DO - No. EASA.21J.020	Service Letter SL 70	Revision 0
--------------------------	---------------------------------	------------

Propeller Snap Ring MTV-33-() and MTV-34-() Propeller

Reason: Definition of tolerances for damaged and/or missing parts of snap rings

Figure 1: Example of damaged snap ring still in place

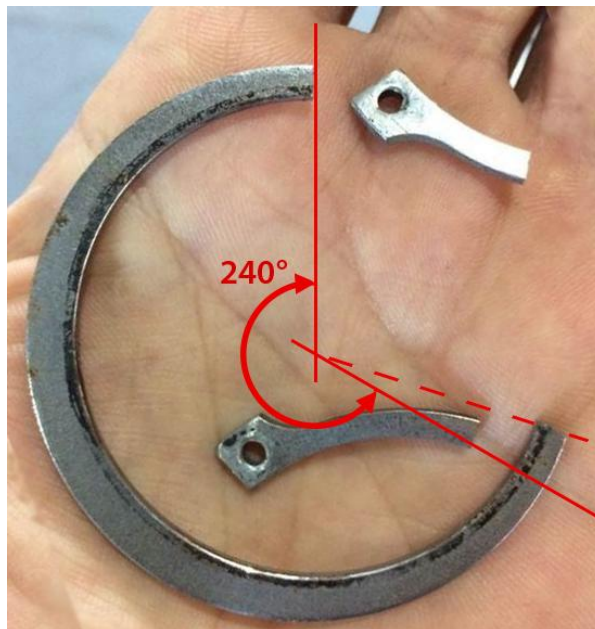
Damaged snap rings that still have 2/3 or more of their circumference intact (see Figure 2) are not a safety issue and aircraft operation may continue.

Damaged snap rings with less than 2/3 of their circumference may get lost during operation.

Operation of the propeller without snap rings may result in excessive grease leak due to excessive wear during engine start and shutdowns. Continued operation is therefore not recommended and the damaged snap rings must be replaced in case their damage is out of the stated tolerance.
